Access Compliance Report

Public Rights-of-Way

Intersection ID: 44754	Main Street: LENOX_POINTE_DR	Cross Street: PIONEER_AV	Location: NE
ADA ID: B5726CEAE8E8	Ramp Type: PerpDiag	Initial Pass/Fail: Fail	Overall Compliance: No
Severity Score: 22.5			
Codes/Mitigation Info/Possible Solution		Field Measurements/Component Compliance

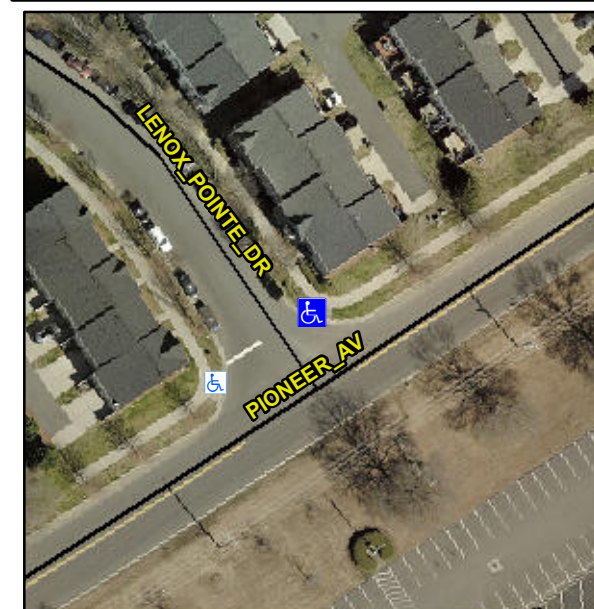
Not Found, R304.5.1, R304.2.2, R304.5.3

Compliance	Description	Data	Compliance	Description	Data
N/A	Ramp Length (in)	78.0	No	Ramp Slope (%)	11.2
No	Ramp Width (in)	47.0	No	Ramp XSlope (%)	2.3
N/A	Flare Type LT	N/A	N/A	Flare Type RT	N/A
N/A	Flare Slope LT (%)	N/A	N/A	Flare Slope RT (%)	N/A
N/A	Flare Traversable LT?	N/A	N/A	Flare Traversable RT?	N/A
N/A	Landing Length (in)	N/A	N/A	DWS Provided?	N/A
N/A	Landing Width (in)	N/A	N/A	DWS Contrast?	N/A
N/A	Landing Slope (%)	N/A	N/A	DWS Length (in)	N/A
N/A	Landing X Slope (%)	N/A	N/A	DWS Full Width?	N/A
N/A	Landing Curb? (Y/N)	N/A	N/A	DWS Offset (in)	N/A
N/A	Shared Landing?	N/A			
N/A	Gutter Ponding?	N/A	N/A	Gutter Slope (%)	N/A
N/A	Gutter Lip Ht (in)	N/A	N/A	Gutter X Slope (%)	N/A
N/A	Painted X Walk1?	No	N/A	Painted X Walk2?	No
	X Walk 1 Direction	To SW		X Walk 2 Direction	To SE
N/A	X Walk 1 Width (in)	N/A	N/A	X Walk 2 Width (in)	N/A
	X Walk 1 Slope (%)	3.2		X Walk 2 Slope (%)	5.6
	X Walk 1 X Slope (%)	5.3		X Walk 2 X Slope (%)	0.5

N/A	Ramp inside XWalk1?	N/A	N/A	Ramp inside XWalk2?	N/A
	Road Slope (%)	3.5	N/A	Clear Space?	N/A
	Road X Slope (%)	4.5	N/A	Clear Space to XWalk (in)	N/A
N/A	Any Obstructions?	N/A	N/A	Storm Grate/Utility Hazard?	N/A
	Obstruction Type			Storm Grate/Utility Type	
		N/A			N/A
			Yes	Surface Condition? (G/P)	Good

Remove & Replace Curb Ramp With Two New Directional Ramps or Equivalent.
